Planning Application 260404 at 24 Delamere Road

To extend a loft conversion by extending the existing roof dormer and to change the roof from sloping hip-end to vertical gable end.

Objection from ACER, The Whitegates Residents Association

Figure 4.37 (continued): Detailed guidance for assessing con

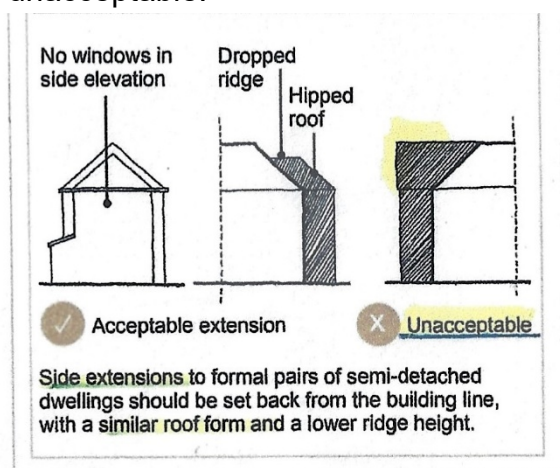
3. All the properties in Delamere Road were built with sloping hip-end roofs which still form the dominant character of the area.
4. There is clear guidance on retention of hip end roofs on side extensions within the Borough Design Guide on page 57, supported by clear unambiguous diagrams shown below, which state that conversion from hip end to gable end is unacceptable.
